Re: Response by the Engineer of Record to Comments Submitted by Atlantic Richfield Company

Concordance Summary: Atlantic Richfield Company (ARCO) Comments/Recommendations, Yankee Doodle Tailings Impoundment

Annotated Version of the Final Report Yankee Doodle Tailings Impoundment, Butte, Montana; Davidson, Morgenstern, Hippley; May 3, 2017

Figure 1. Study Section 8+00W originally from Knight Piésold for proposed, raised conditions and used for our analyses.

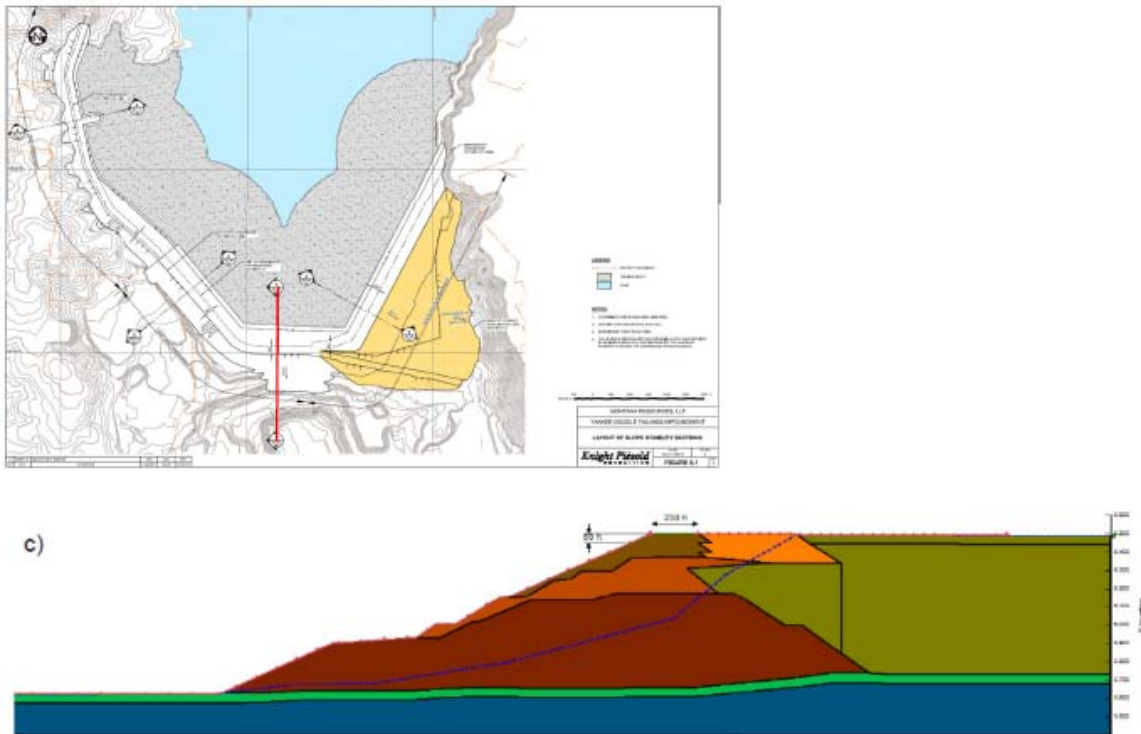
7-15 7-15a 7-15b 7-15c	Comment	<p><i>Performed screening-level analyses based on the cross-sections presented on Figure 5.2(c) and 5.2(d) of the Stability Assessment Report.</i></p> <ul style="list-style-type: none"> - <i>For Case 1, the calculated factors of safety range from 0.89 to 1.03 compared with 1.7 to 2.0 given in Table 5.2 of the Stability Assessment Report. A factor of safety of less than 1.0 would indicate failure.</i> - <i>For Case 2 the undrained strength ratio for the degraded rockfill is modeled with an anisotropic strength ranging from 0.25 for horizontal portions of the shear surface and 0.30 for the steeper portions of the failure surface...</i> - <i>For Case 2, the calculated factors of safety range from 0.95 to 0.96, which also indicate failure.</i> 	<p>The screening level stability analyses are based on the incorrect geotechnical and hydrogeological models of the East-West Embankment.</p> <p>The hydrogeological (pore pressure) conditions applied in the ARCO screening level assessment apply hydrostatic pore pressure conditions to the embankment fill below the piezometric line. This characterization of pore pressures is not supported by measured piezometric data or observations within the drill core during sonic drilling. A summary of the appropriate piezometric characterization for the East-West Embankment is provided in the Site Characterization Report (Rev 2) and the Stability Assessment Report (Rev 2).</p> <p>An incorrect application of undrained shear strengths has compounded the inaccuracy of the screening level calculations. ARCO has incorrectly applied undrained shear strengths to well drained rockfill materials below the incorrectly inferred piezometric line. These low shear strength values are unrealistic for the drained rockfill materials that have been utilized to construct the embankment.</p> <p>The ARCO FoS are based on a geotechnical model with embankment materials having undrained shear strength characteristics equivalent to a weak normally consolidated clay material. The analyses assume that these materials exist as a massive zone of embankment fill comprising approximately half of the embankment. ARCO has not properly accounted for the true nature of the embankment fill material, the orientation of the rockfill fabric, nor the free draining nature of the materials.</p>

We have performed screening-level analyses based on the cross-sections presented on Figure 5.2(c) and 5.2(d) of the Stability Assessment Report. Figure 5.2(c) is re-presented on Figure 1 along with a plan view showing the location of the study section evaluated. Our screening-level analyses are not presented as design calculations, but are intended to illustrate the sensitivity of the design to undrained stability calculations. The calculations are made for static conditions alone for the proposed geometry and should be compared with those presented for static conditions. For Case 1, the calculated factors of safety range from 0.89 to 1.03 compared with 1.7 to 2.0 given in Table 5.2 of the Stability Assessment Report. A factor of safety of less than 1.0 would indicate failure. Figure 2 presents slope stability analysis results for Case 1. For Case 2 the undrained strength ratio for the degraded rockfill is modeled with an anisotropic strength ranging from 0.25 for horizontal portions of the shear surface and 0.30 for the steeper portions of the failure surface. For the tailings and the saturated historic rockfill portions of the model, the two undrained strength ratios of 0.25 and 0.3 were used again. For Case 2, the calculated factors of safety range from 0.95 to 0.96, which also indicate failure. These results are presented on Figure 3.
